# SERVICETEKNOTES

## TABLE OF CONTENTS

S-3200 2943/2944 CORRECTION FOR SIGNAL  
EDGE JITTER

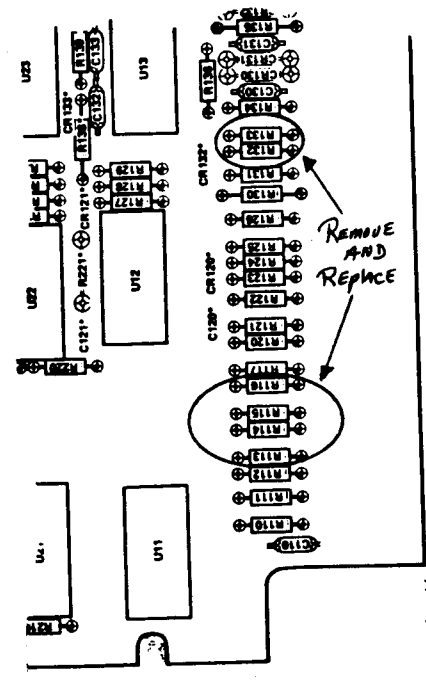
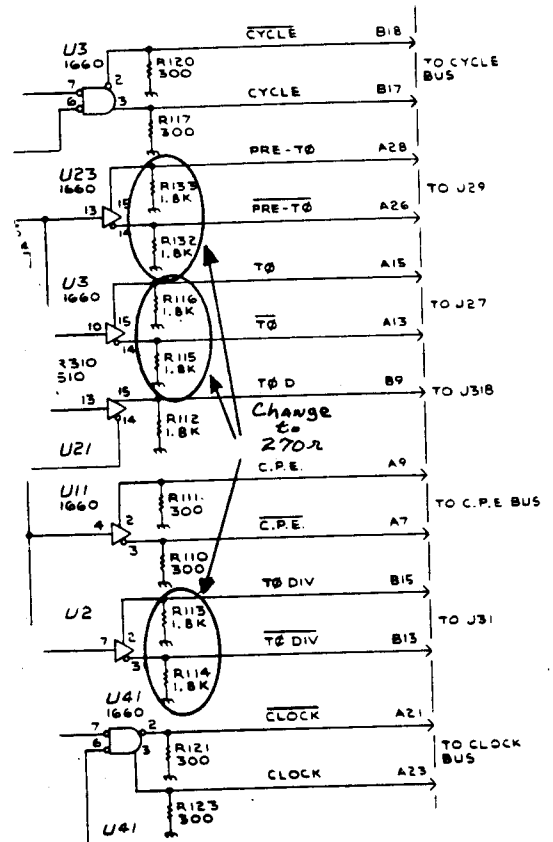
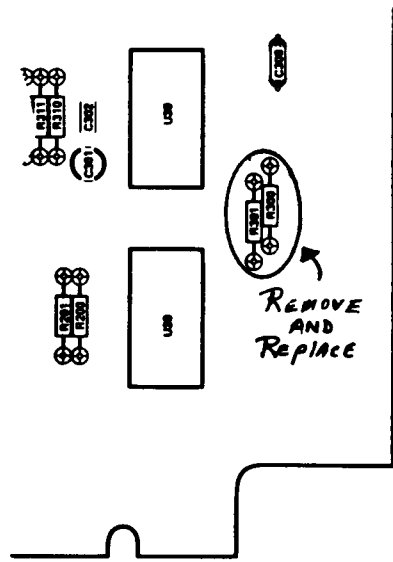
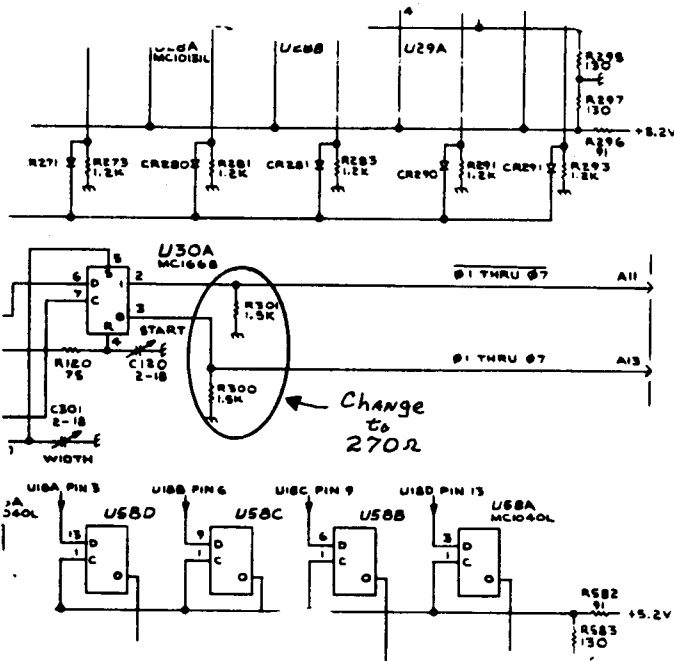
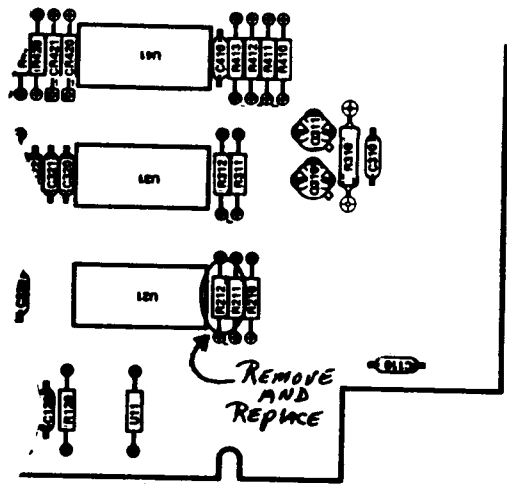
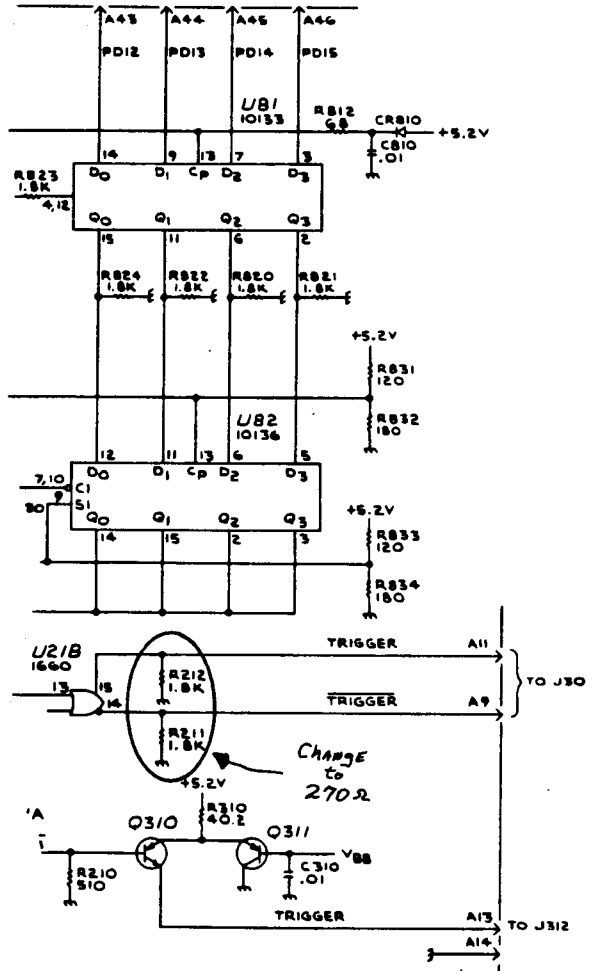
In some 2943/2944 clock generators the clock signal edges may vary (jitter) between 400 ps to 1 ns. The jitter is caused by high signal impedance, signal sources and cross talk to adjacent signals.

The solution is to decrease source impedance to increase the drive current. This will stabilize the signal and reduce cross talk effects.

On the Cycle Length Board 670-5383-05 change R113, R114, R115, R116, R132, R133 from 1.8K P/N 315-0182-00 to a 270 ohm P/N 315-0271-00. Change board P/N to 670-5383-06. On the Clock Phase Board 670-5425-01 change R300 and R301 from a 1.5K ohm P/N 315-0152-00 to a 270 ohm P/N 315-0271-00, change board P/N to 670-5425-02. On the Programmed Cycle Board 670-5417-01 change R211 and R212 from 1.8K ohm P/N 315-0182-00 to 270 ohm P/N 315-0271-00, change board P/N to 670-5417-02.

Figure 1. Drive 0

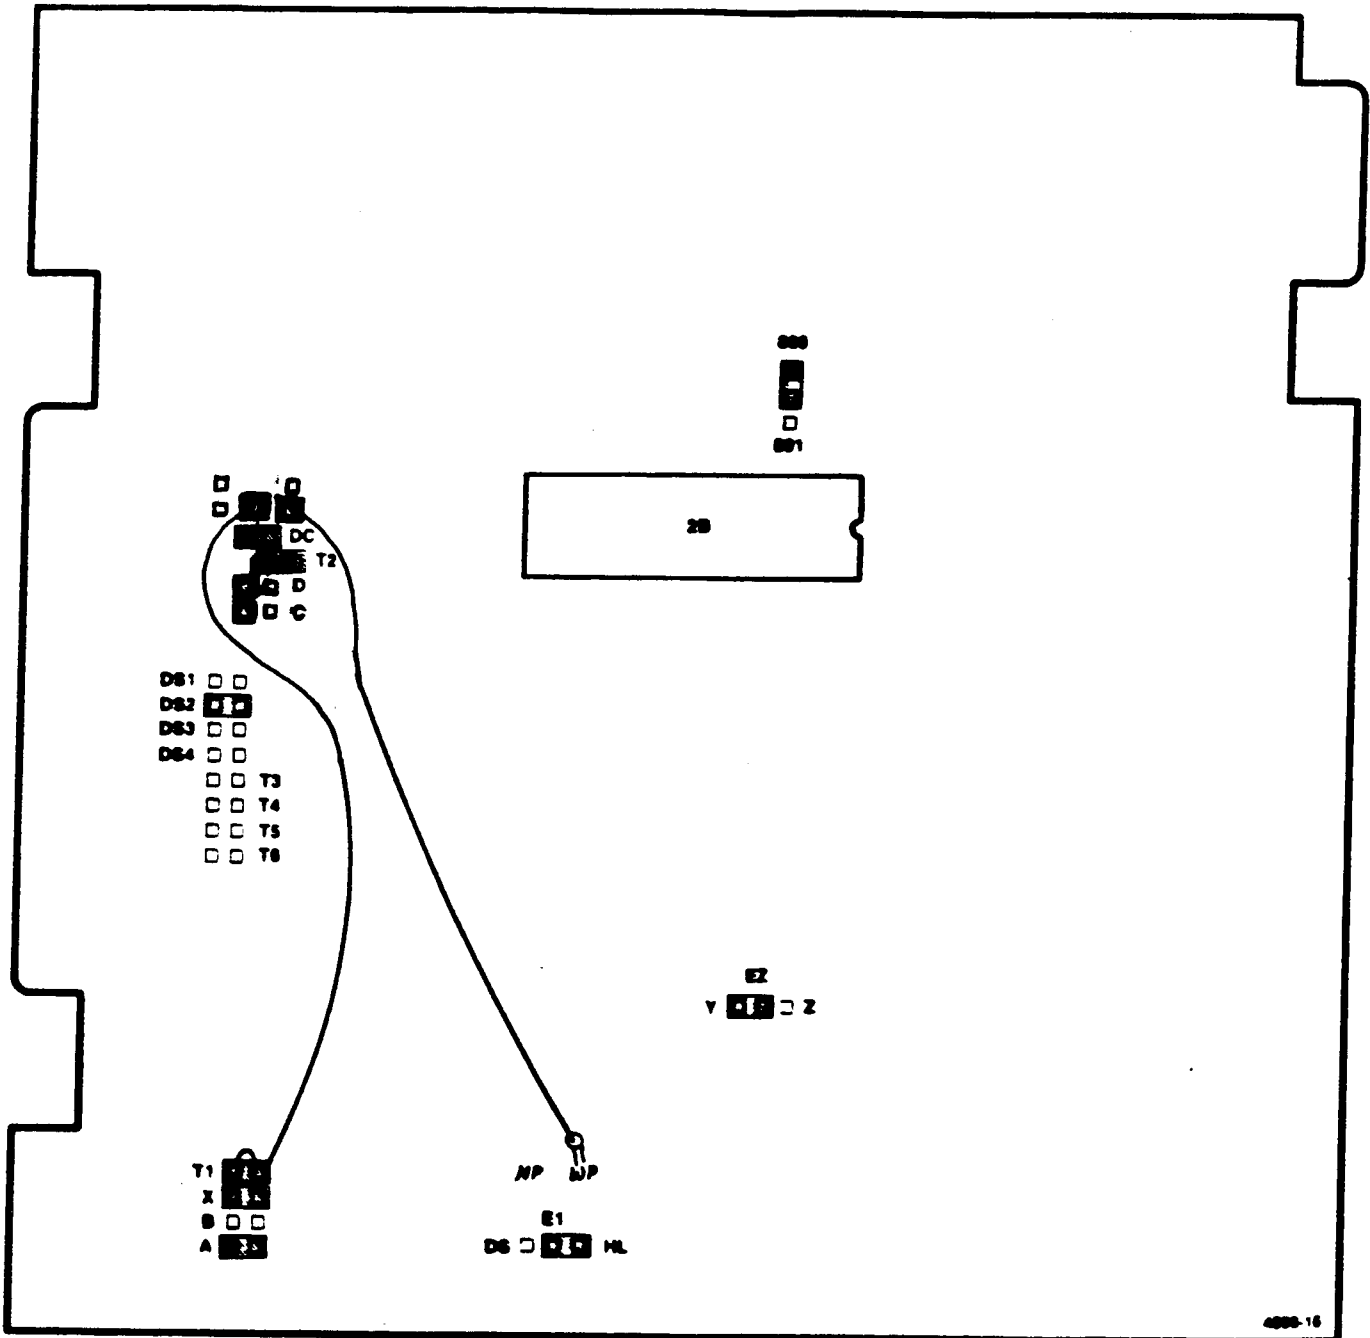
The wire jumpers that we install are different. The wires are installed as shown in fig. 1 and fig. 2. The cables and straps will be covered in the F45 Disk Option Service Manual (available Week 36) and a correction is being done to the F42/43 Disk Option Service Manual.

Fig 1. Schematic Diagram

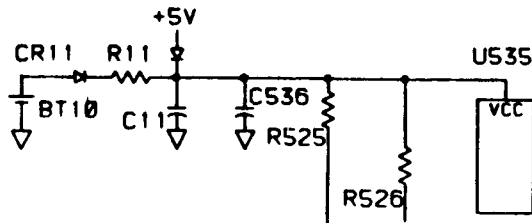
The NiCad battery on the Processor board has had a high rate of failures. This battery, p.n. 146-0040-00, is used to power the CMOS RAM which stores the user selectable operating parameters. If the battery fails, the set up parameter stored will be returned to their default conditions. This is indicated by a message, "Setup Default Reset", displayed on the screen at power-up. The replacement battery is a lithium battery, p.n. 146-0045-00, with a life rating of ten years, and requires no charging circuit. The charging circuit components will be removed with the old NiCad battery.

To implement Mod 51340, refer to Fig. 1 and 2 while doing the following steps:

1. Remove CR9, CR10, CR11, BT10, R11.
2. Add new CR10 (152-0322-00) to replace old CR10.
3. Cut run on surface of board between R11 and CR11.
4. Insert CR11 (152-0322-00) where R11 was removed. Place CR11 in the circuit so the anode is to the battery and the cathode is connected to the run just cut.
5. Move R9 (270 ohms) to bridge the cut run. Attaching one leg to the cathode of CR11 and the second leg to the pad at the other end of the cut run. This 270 ohm resistor will now be referred to as R11.
6. Install the new battery to replace the old battery which was removed. Keep the negative lead short. This battery is slightly longer than the one removed. It will need to be installed at a slight angle for clearance. Use the insulation to cover the positive lead which will need to loop back to the pad labeled with a plus.
